Subject: AP1000 COL Standard Design Change Resubmittal of Sensitive and Non-Sensitive
Versions of APP-GW-GLR-016, Revision 0

APP-GW-GLR-016, Rev. 0

“AP1000 Pressurizer Design”

AP1000 Pressurizer Design

Figure 1.2-1
Reactor Coolant System

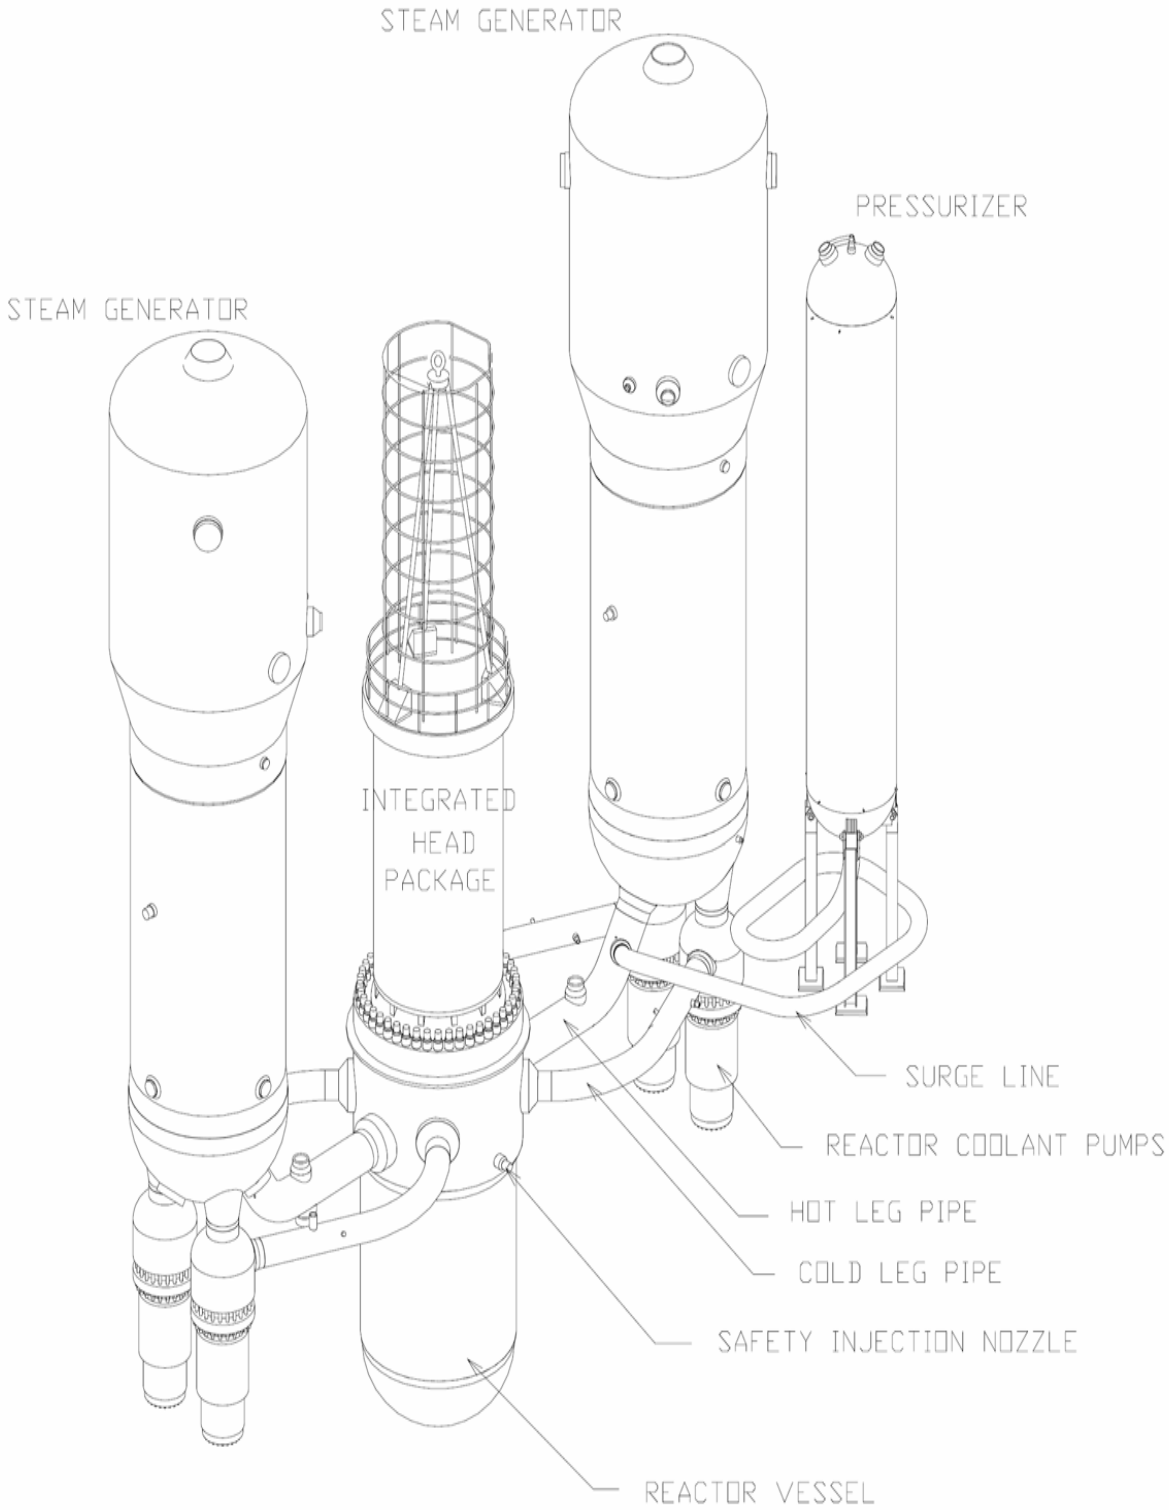
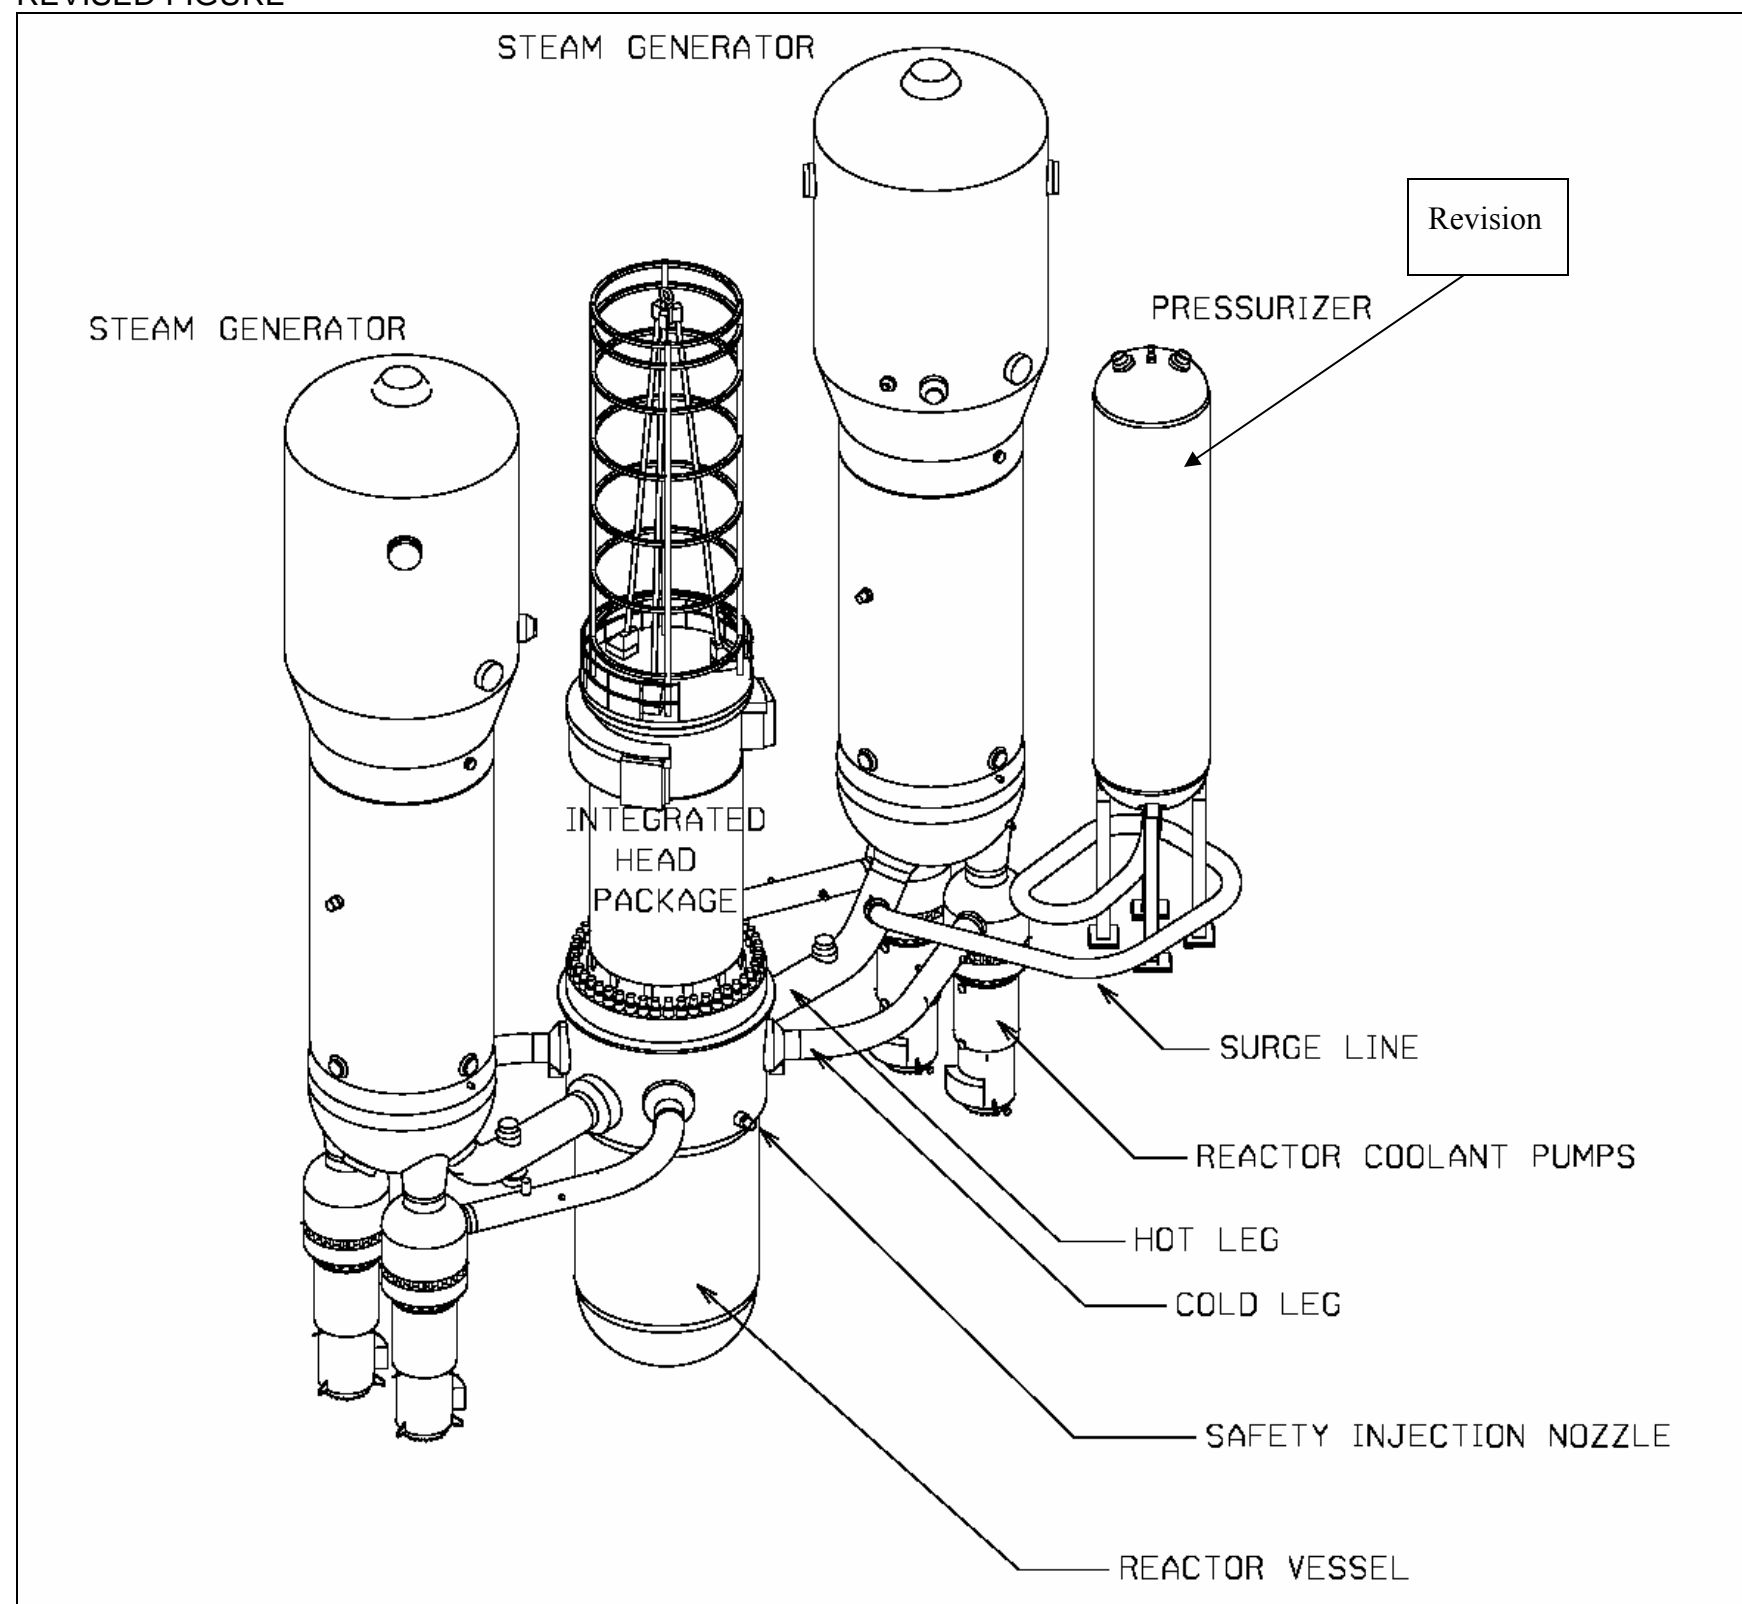
The design of the pressurizer is addressed in subsection 5.1.3.5 and 5.4.5 of the NRC Final Safety Evaluation Report (FSER, Reference 2) write-ups. The change in the pressurizer configuration will impact Figure 1.2-1 AP1000 Reactor Coolant System of the FSER by changing the aspect ratio of the pressurizer in the figure. This change does not, however, change the design functions of the pressurizer.

Figure 3.8.3-6 (Sheet 2 of 4)
Pressurizer Lower Lateral Supports

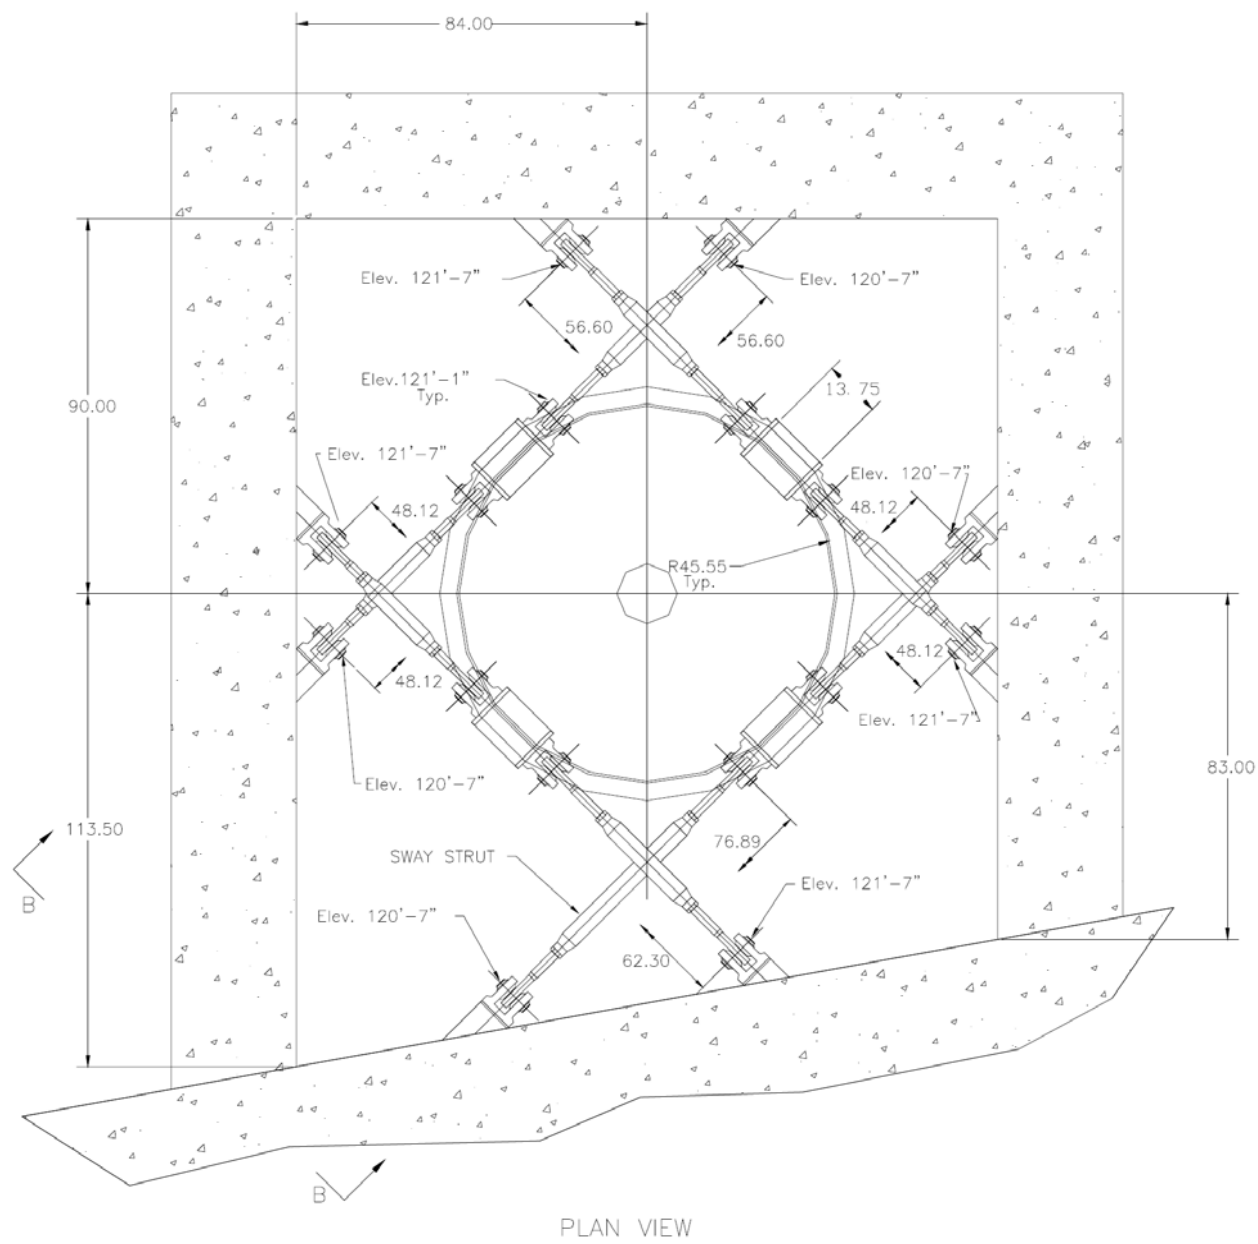
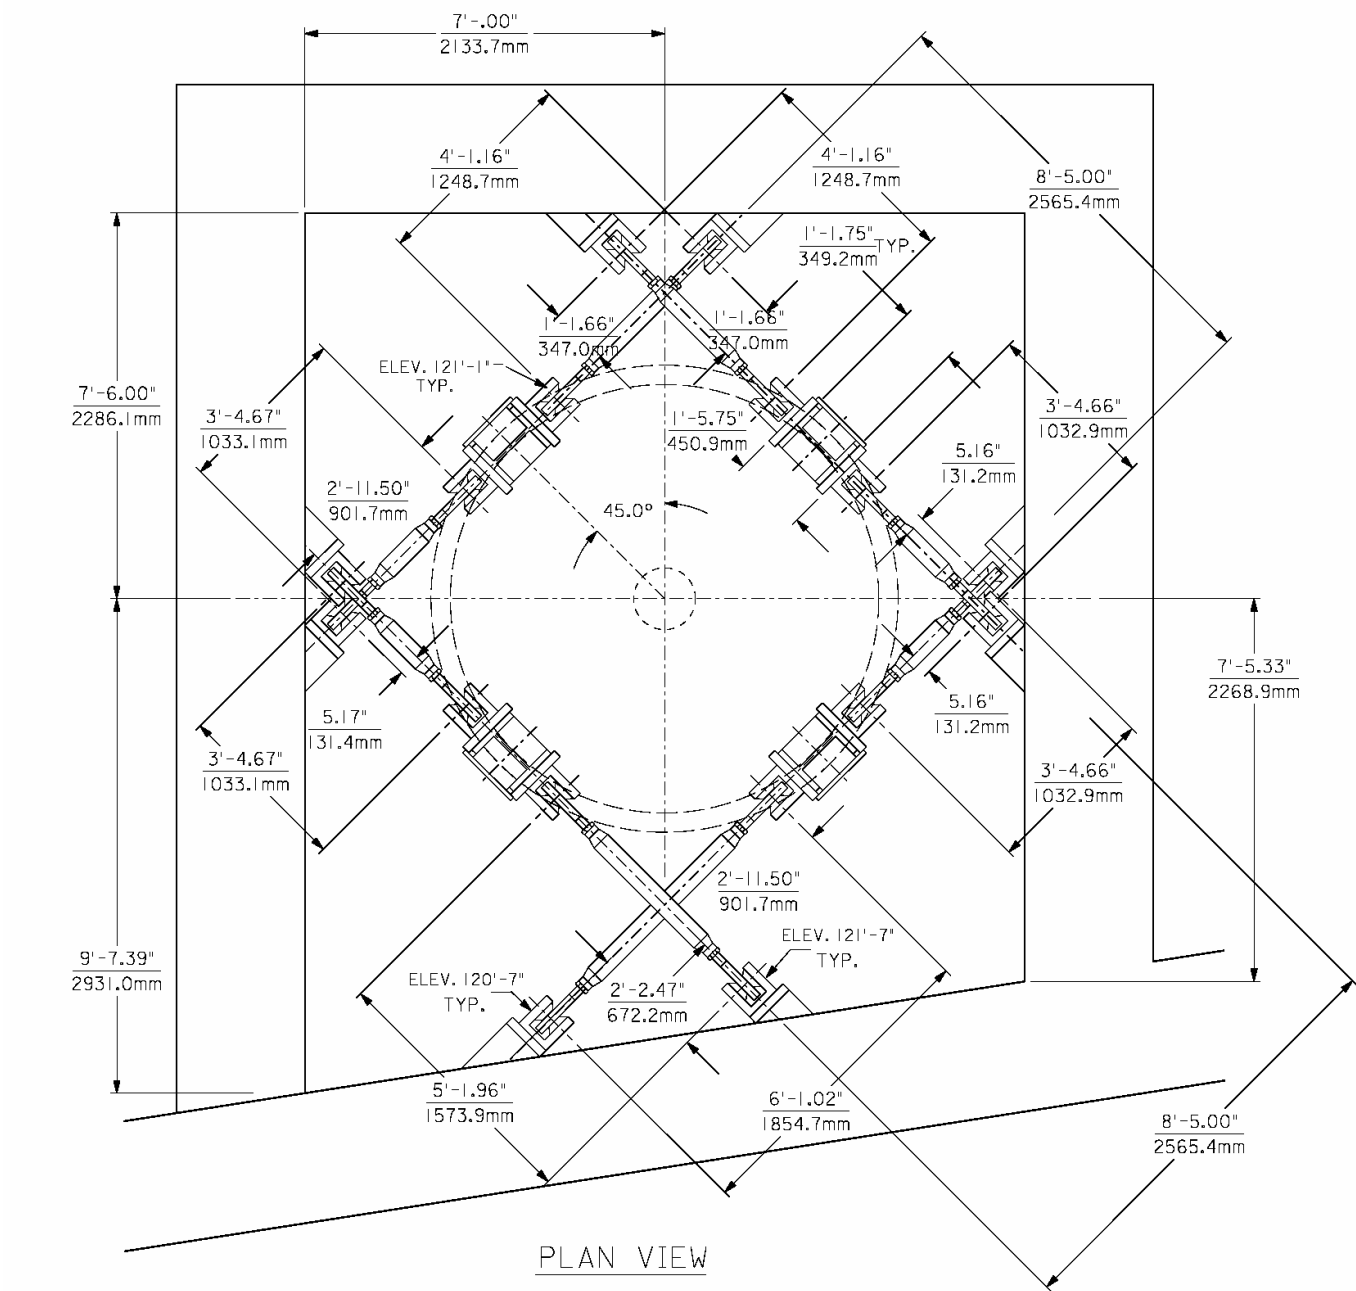
The DCD figure, 3.8.3-6 (Sheet 2 of 4) was altered to show the pin dimensions in an alternate format. On the existing drawings, the pin to pin dimensions are shown using a double arrow. On the revised figure, these dimensions are shown from point to point.
